**General Bid Bulletin No. 14
26 February 2021**

IFB NO. 20-031-6

**SOUTH COMMUTER RAILWAY PROJECT
FOR PACKAGES CP S-04, CP S-05, AND CP S-07
CONSTRUCTION OF CIVIL STRUCTURES: VIADUCTS, BRIDGES,
NINE (9) STATIONS AND DEPOT**

CP S04-07 Responses to Clarification Requests (Batch 6)

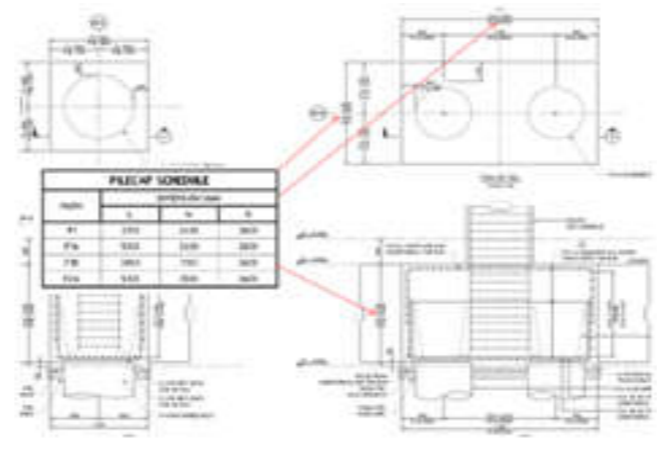
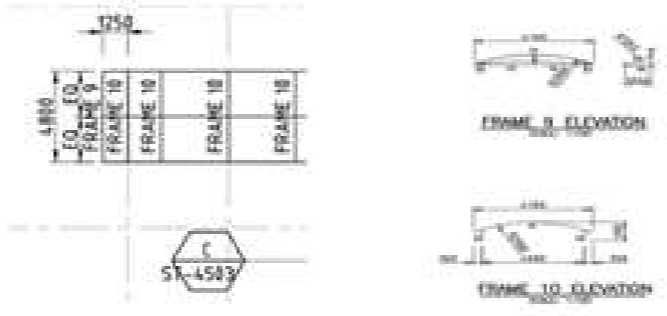
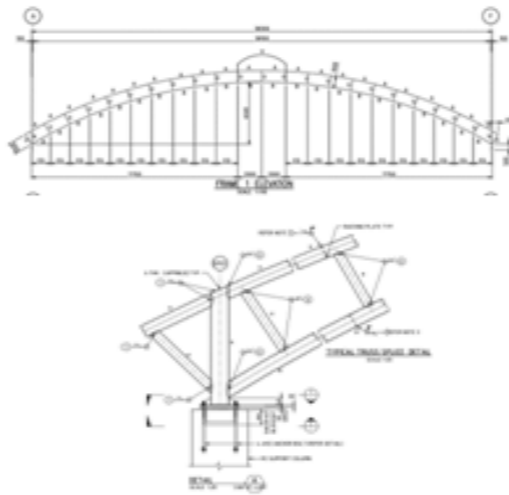
S-07	2	Book 2 (Architectural) Structural LRS Building	-	NSRP-DWG-LRS-ST-4401 Wall Schedules	-	Please provide Structural Details and Blow Up Plan of TS1 at Ground Floor Level	<i>Structural detail of TS1 can be found on sheet NSRP-DWG-LRS-ST-4410 rev 21</i>
S-07	2	Book 2 (Architectural) Structural LRS Building	-	NSRP-DWG-LRS-ST-4401 Wall Schedules	-	Please provide location of W15.	<i>W15 can be found on drawing sheets NSRP-DWG-LRS-ST-4201 rev 21 NSRP-DWG-LRS-ST-4211 rev 21 NSRP-DWG-LRS-ST-4221 rev 21.1</i>
S-07	1A	Section 4A Bidding Forms – Bill of Quantities (BOQ)	-	Bill No. 4-1.1 OCC Building	-	Please provide Blow-up Plans and details (Architectural) for EPS.	<i>New detail drawing for EPS will be issued in Addendum 2</i>

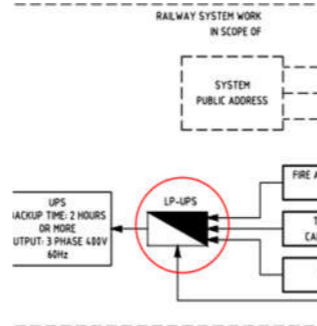
S-07	1	1.3 CP S-07 Vol.1A Sec.4A BOQ 201001, SO7/Volume2/0 2_Book2 (Architectural)/0 3_S07	-		Panel LRS-UPS	Not specified (SLD and load Schedule), LP-UPS and LP-UPS1 are specified in the diagram	<i>Refer to NSRP-DWG-LRS-EL-5021 rev21 for SLD. NRP-DWG-LRS-EL-5677 rev21 for load schedule.</i>
S-07	1	1.3 CP S-07 Vol.1A Sec.4A BOQ 201001, SO7/Volume2/0 2_Book2 (Architectural)/0 3_S07	-		Control Panel for VF & MRV for LRS	Not specified (SLD and load Schedule)	<i>To be coordinated with the vendor. Remote switch for EF & SF. For reference, see NSRP- DWG-LRS-EL-5035 for typical control circuit schematic.</i>
S-07	1	1.3 CP S-07 Vol.1A Sec.4A BOQ 201001, SO7/Volume2/0 2_Book2 (Architectural)/0 3_S07	-		Control Panel for EF & SF for LRS	Not specified (SLD and load Schedule)	<i>To be coordinated with the vendor. Remote switch for EF & SF. For reference, see NSRP- DWG-LRS-EL-5035 for typical control circuit schematic.</i>

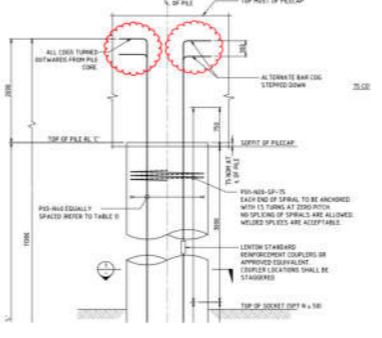
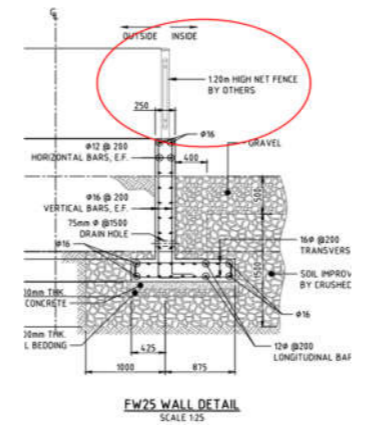
S-04	1	Sec 4A BOQ	26		At BOQ, - Cross Hole sonic Logging test - 38 nos At Technical Specification, - Shall intall access tubes for CSL testing in all bored piles.	There is discrepancy between BOQ and Technical Specification. Please, Clarify it.	<i>There is no discrepancy between TS and BoQ Qty. The Technical Specification states that the number of piles to be tested by this method shall be 3% of all piles which is the same as BOQ calculations. (see 204.2.6.4)</i>

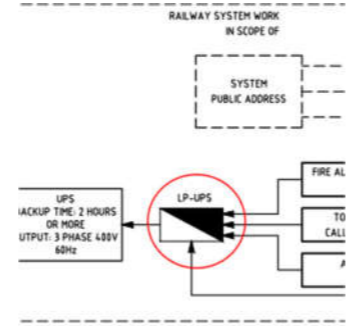
S-04	2	Sec 6 II drawing CP S-04_VIA04	33		<p>At CP S-04_VIA04, Page 33 MT04-Abut : Pier type - ABUT-6.3</p>	<p>Please, provide the pile drawing and the pile details for pier type ABUT-6.3.</p>	<p><i>For abutment concrete and rebar details of MT04-Abut, please refer to NSRP-DWG-CIS70-ST-0101 Rev 21, NSRP-DWG-CIS70-ST-0102 Rev 21, NSRP-DWG-CIS70-ST-0103 Rev 21.</i></p>
S-04	2	Sec 6 II drawing CP S-04_VIA00	30			<p>Please, provide the length of X for pile reinforcement for type P5.</p>	<p><i>Value of X shall be shown in the drawing NSRP-DWG-VIA00-ST-0323, NSRP-DWG-VIA00-ST-0324, NSRP-DWG-VIA00-ST-0325. Drawings will be revised and issued as rev. 21.2</i></p>

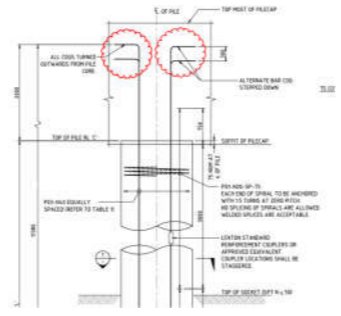
S-05	2	Sec 6 II drawing CP S-05_VIA00	30			Please, provide the length of X for pile reinforcement for type P5.	<i>Value of X shall be shown in the drawing NSRP-DWG-VIA00-ST-0323, NSRP-DWG-VIA00-ST-0324, NSRP-DWG-VIA00-ST-0325. Drawings will be revised and issued as rev. 21.2</i>
S-05	2	Sec.6	GS131	131.4	The Contractor shall erect high visibility safety fencing along the demarcation line of the PNR safety zones and shall ensure that the safety fences are duly maintained and kept in good order at all times.	<ol style="list-style-type: none"> Please explain the meaning of "high visibility" in GS131.4. The steel mesh type of fence is match with high visibility safety fencing in GS131.4 or not. 	<i>The purpose of safety fence is protection of PNR Operation. The fence shall be subject to method of construction.</i>
S-05		CP S-05_02_Structural_SS_10-14	NSRP-DWG-SS10-ST-4311 NSRP-DWG-SS11-ST-4311 NSRP-DWG-SS12-ST-4311 NSRP-DWG-SS13-ST-4311 NSRP-DWG-SS14-ST-4311			<p>There is discrepancy between BOQ and design drawing for fence works</p> <ul style="list-style-type: none"> - in BOQ : 128 (4) Fencing (CHB t=150mm x 2500mm high) - in Design drawing : 1.20m high net fence by others <p>Please clarify above item.</p>	<p><i>- BOQ to be revised and issued in Addendum 2</i></p> <p><i>- The following structural plans will be updated to revision 21.2:</i></p> <p><i>NSRP-DWG-SS10-ST-4311</i></p> <p><i>NSRP-DWG-SS11-ST-4311</i></p> <p><i>NSRP-DWG-SS12-ST-4311</i></p> <p><i>NSRP-DWG-SS13-ST-4311</i></p> <p><i>NSRP-DWG-SS14-ST-4311</i></p>

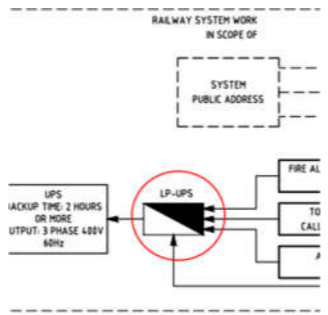
S-05		<p>CP S-05_03_BIN_EL</p> <p>CP S-05_03_PTA_EL</p> <p>CP S-05_03_SPO_EL</p> <p>CP S-05_03_SRO_EL</p>	<p>NSRP-DWG-BIN-EL-5801</p> <p>NSRP-DWG-PTA-EL-5801</p> <p>NSRP-DWG-SPO-EL-5801</p> <p>NSRP-DWG-SRO-EL-5801</p>	BMS DIAGRAM		<p>There is discrepancy between BOQ and design drawing for BMS works</p> <ul style="list-style-type: none"> - in BOQ : 713(7) UPS BACKUP TIME : 2HOURS OR MORE - in Design drawing : LP -UPS INC UPS BACKUP TIME : 2HOURS OR MOR <p>Please clarify above item.</p>	<p><i>Pay item for LP - UPS is included as follows:</i></p> <p><i>Bill No. 4-1, Part F.5 --- Electrical Works PIN 706(13)ak --- SPO - LP UPS incl 30kVA UPS</i></p> <p><i>Bill No. 4-2, Part F.5 --- Electrical Works PIN 706(14)ae --- PTA - LP UPS incl 30kVA UPS</i></p> <p><i>Bill No. 4-3, Part F.5 --- Electrical Works PIN 706(15)ah --- BIN - LP UPS incl 30kVA UPS</i></p> <p><i>BOQ for Bill No. 4-4 (Sta. Rosa Station) will be revised to include pay item for LP UPS. Revised BOQ will be issued in Addendum 2</i></p>

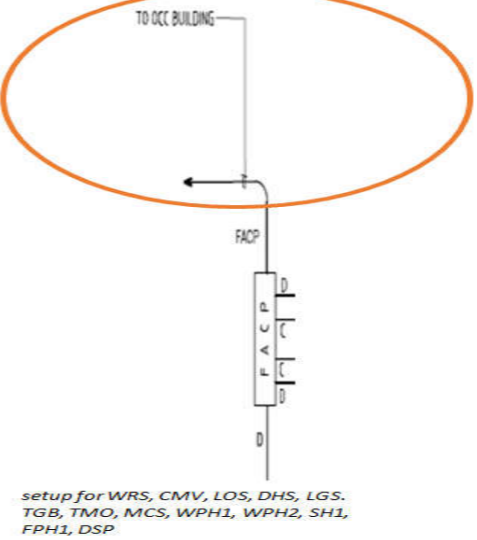
S-07	2	01, Specifications, TS200 Bridges and Viaducts Annex A	10 of 56	TS 204 Bored Pile	TS 204.1.1.4 Permanent Casing; 201.1.2 Payment (Measurement for payment for permanent casing shall be the number of unit in "linear meter" of each diameter of required permanent casing installed as specified in Section エラー! 参照元が見つかりません。)	Please provide pay item for Permanent Casing intended for bored piling	<p><i>The Bidder should include the cost of steel casing or permanent casing in pay items 204(2)a and 204(2)c.</i></p>
S-07	2	02 Book 1 (Civil), 03_Cp C07 Structures	DB1: 104 of 127 DB2: 119 of 127	NSRP-DWG-DB1-ST-4102/4112; NSRP-DWG-DB2-ST-4102/4112	Detention Basin 1 & 2	Please provide pay item and specifications for Cat Ladder with Cage	<p><i>BoQ will be revised to include pay item for steel gratings for Exterior Trench Drain and Waste Water Gutter Trench.</i></p> <p><i>Revised BOQ will be issued in Addendum 2</i></p>
